**MAINE DEPARTMENT OF
INLAND FISHERIES AND WILDLIFE**

ADDENDUM NO. 2

**EFFLUENT CHARACTERISTIC DESIGN AT
EMBDEN REARING STATION**

BGS PROJECT NO.: 3289

SHEET
12S-101

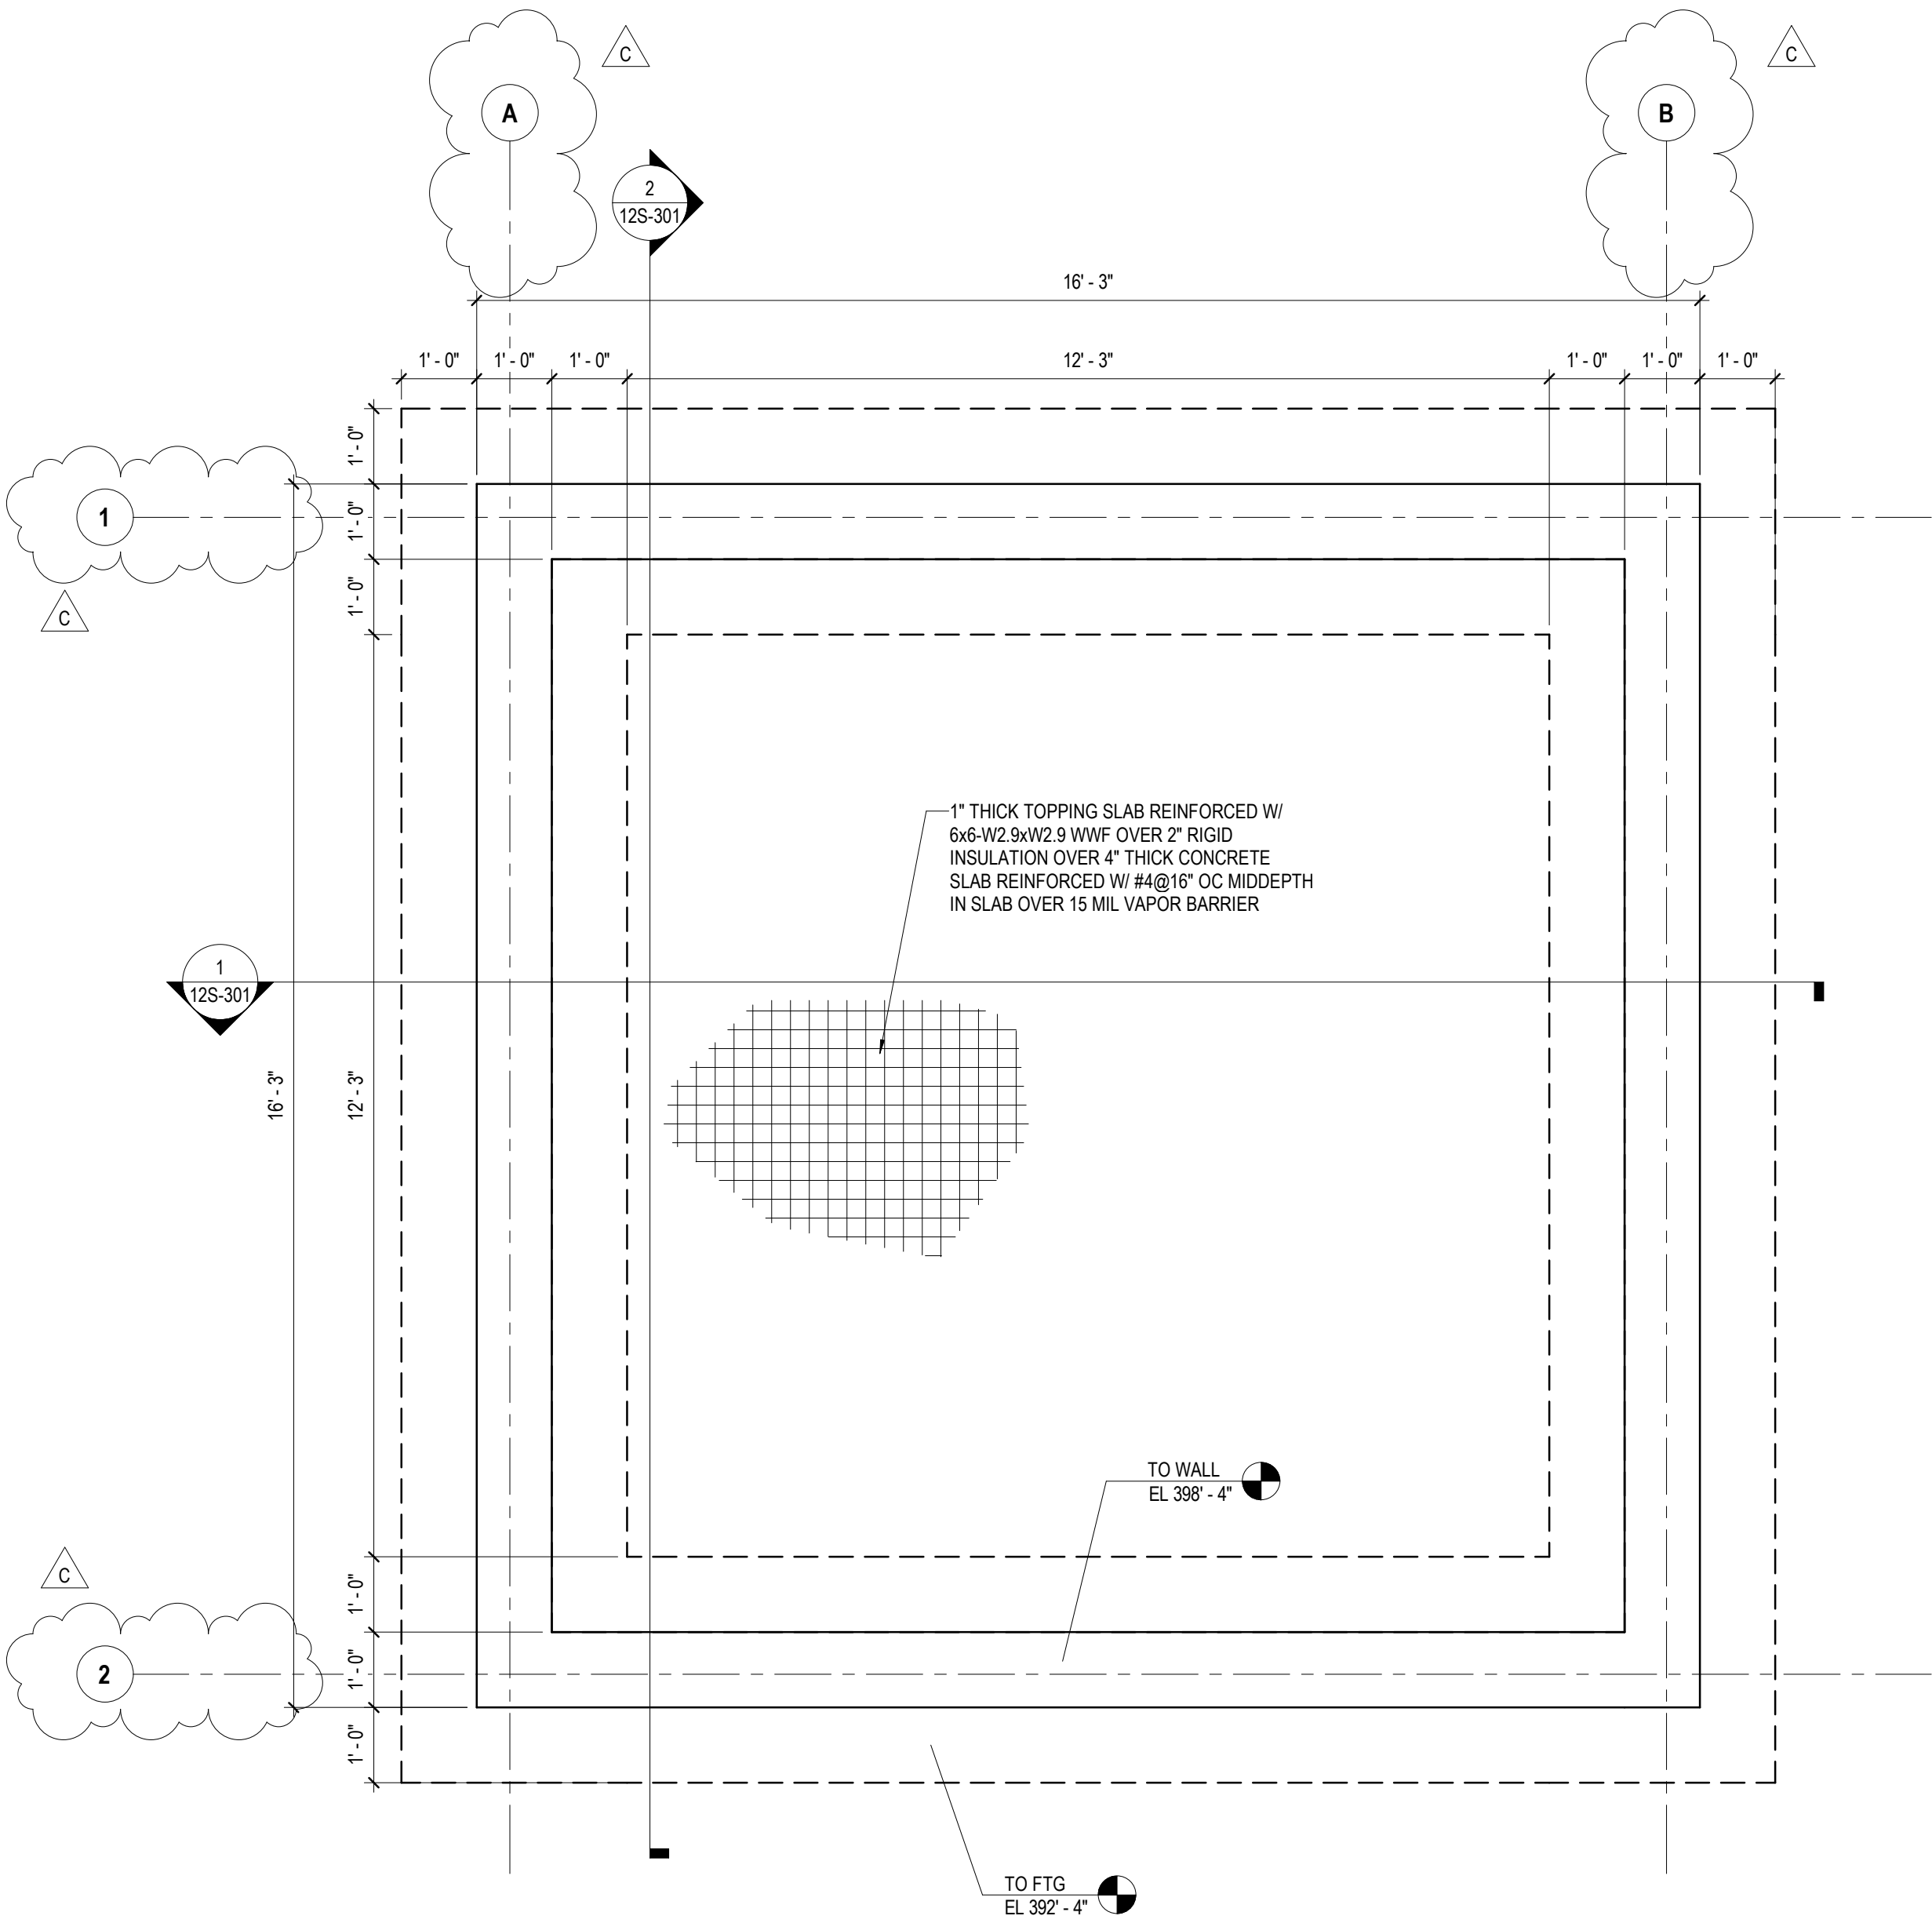
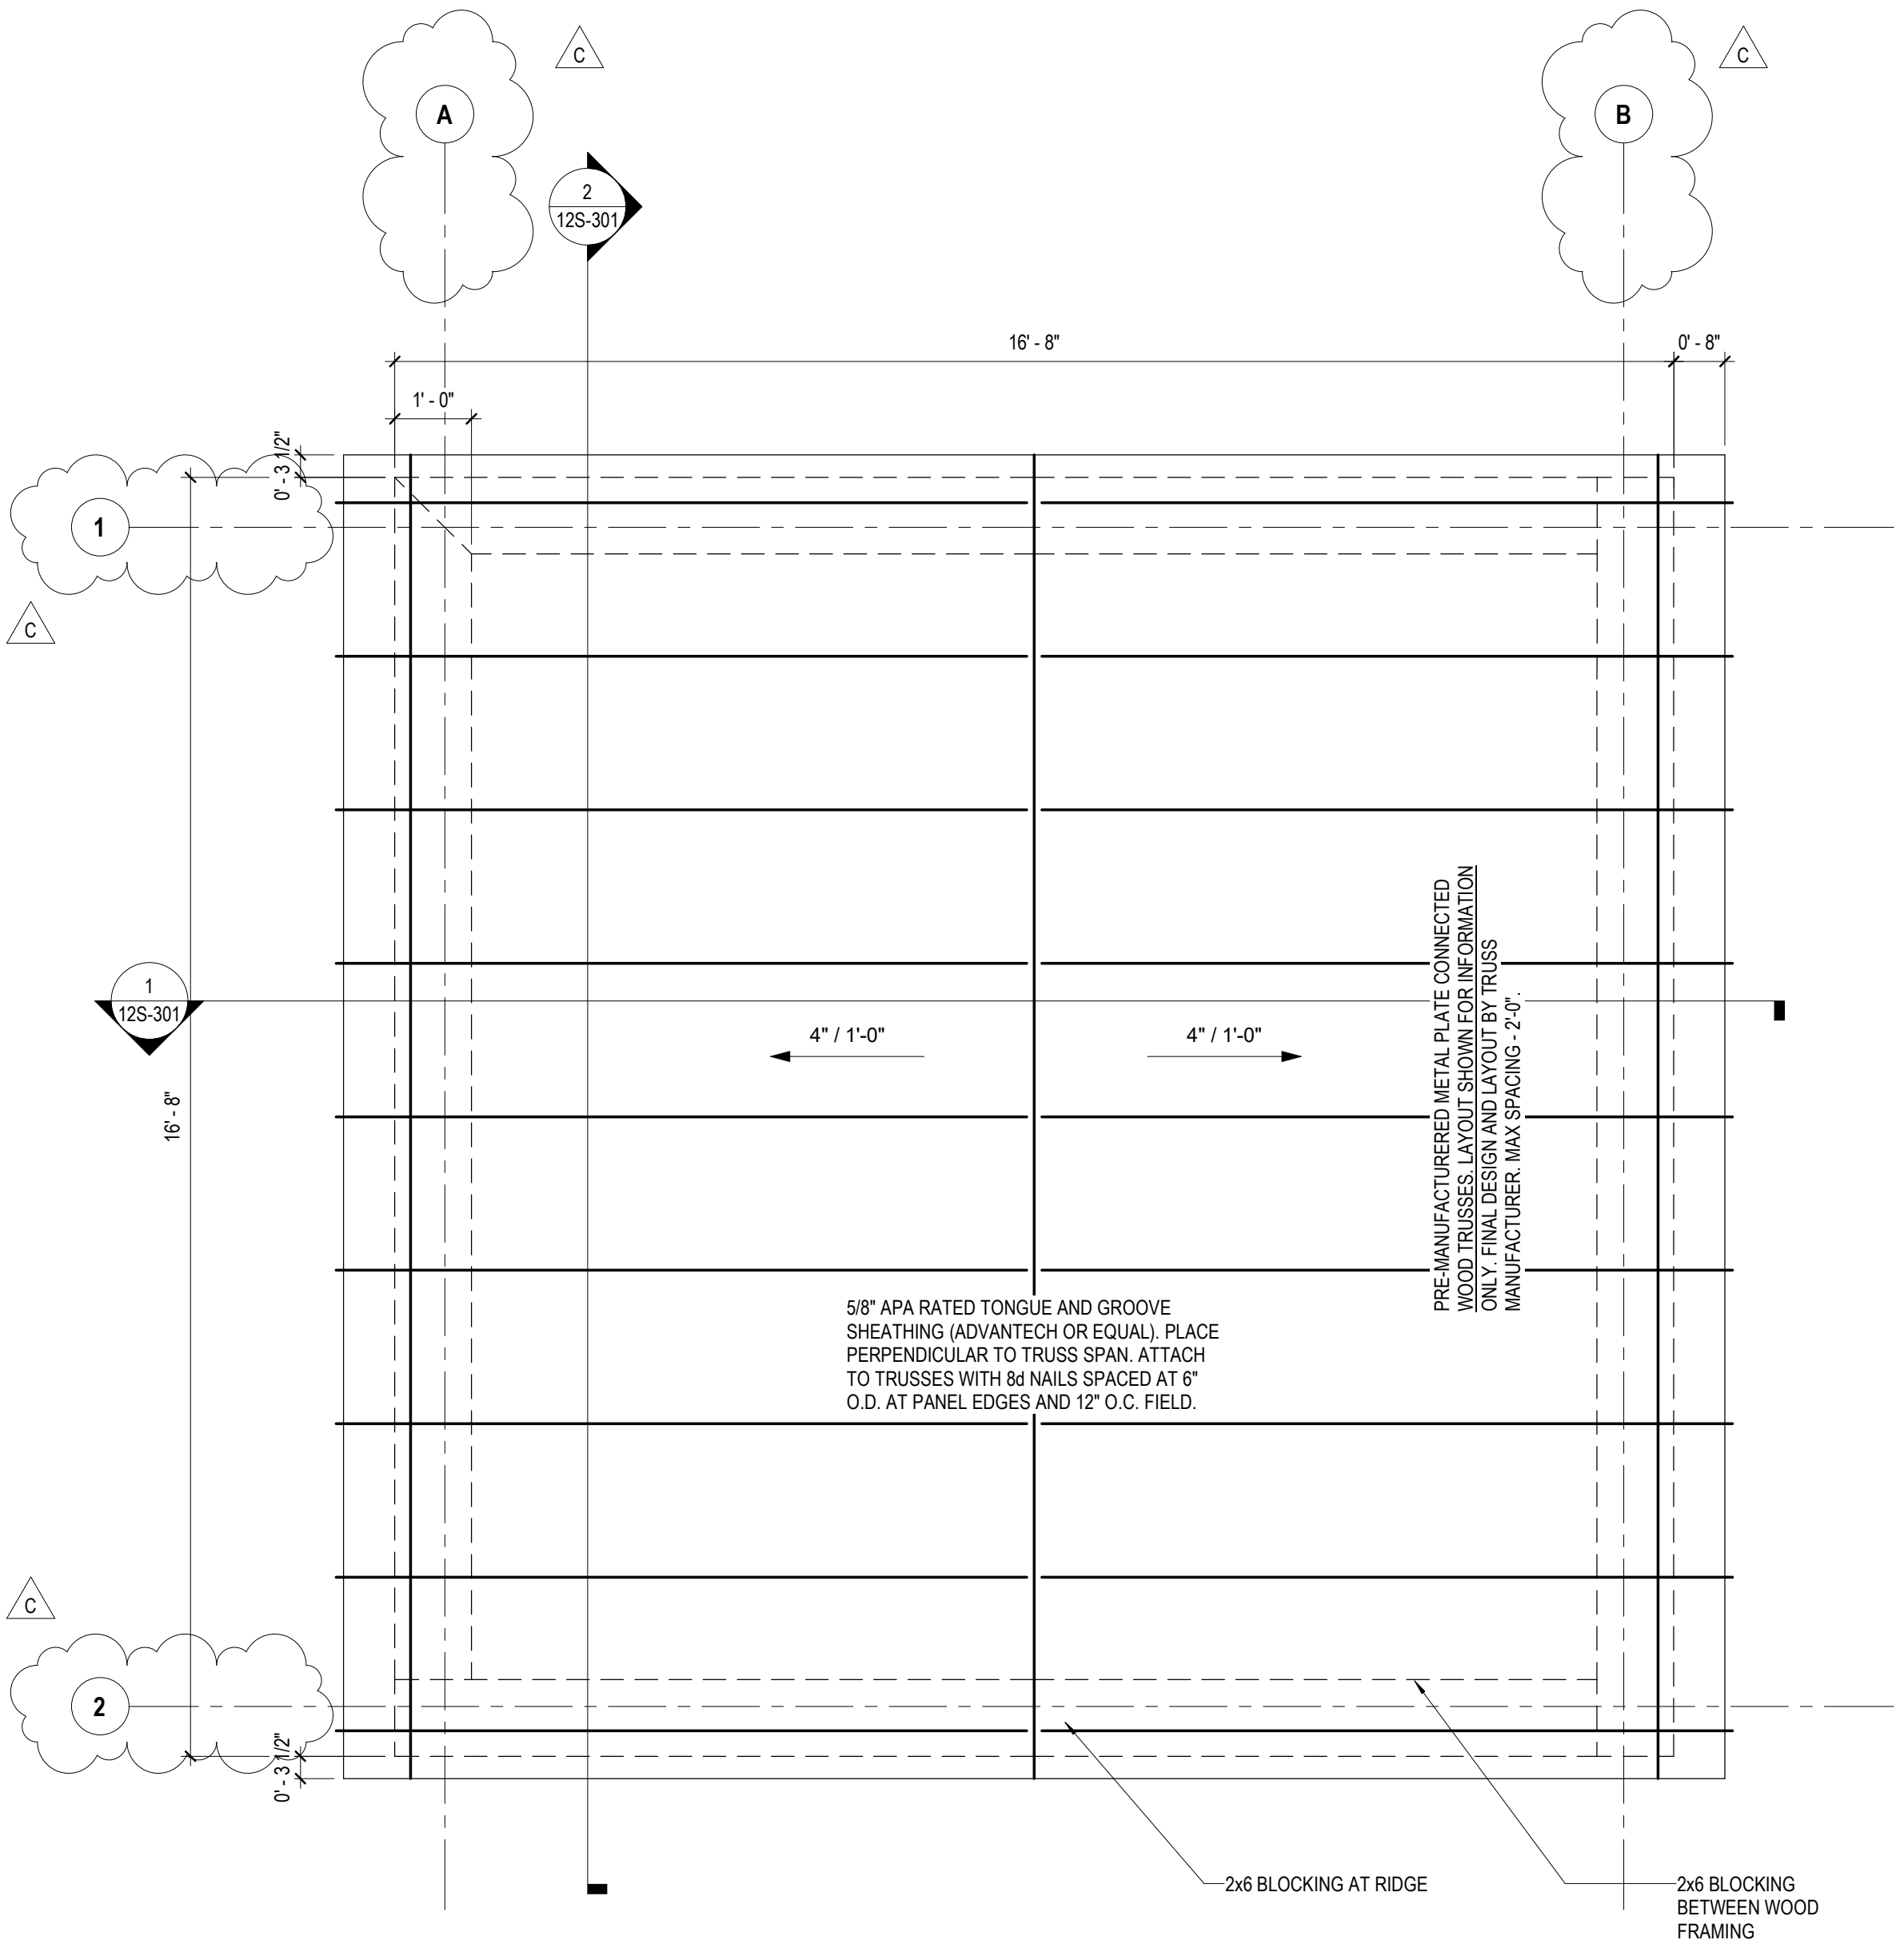
- 37. QUESTION:** 12S-101 : CHEMICAL DOSING BUILDING STRUCTURAL PLANS: Chemical Dosing Building Add Alt #1, Section #1 & #2- 12S-301: Have 2" thick concrete with ww reinforcing and 4" thick concrete slab. 12S-101-Foundation plan has 1" thick. Please confirm this detail

- 38. QUESTION:** 12S-101 : CHEMICAL DOSING BUILDING STRUCTURAL PLANS: At the exterior door, is there a slab detail? Is there a dimension to locate this door opening? Does this slab step down?

- 39. QUESTION:** 12S-101 : CHEMICAL DOSING BUILDING STRUCTURAL PLANS: Are there column grids on the structural sheet to coordinate with the structural details and column grid on the architectural sheets?

- 40. QUESTION:** 12S-303 : ROOF FRAMING SECTIONS AND DETAILS: 4/12S-303: Is there a dimension to locate the CMU wall on the foundation wall? The Foundation plan on the Structural sheets do not have column grids

ANSWER: This detail is correct. 2" topping slab over rigid insulation over 4" slab on grade.

ANSWER: There is no door stoop at this location.

ANSWER: Column grids will be shown on the structural sheet for reference.

ANSWER: The out to out concrete foundation wall dimensions shown on sheet 12S-101 shall be 16'-8" x 16'-8" in lieu of 16'-3" x 16'-3". The INTERIOR face of cmu wall will align with the interior face of the concrete foundation wall.
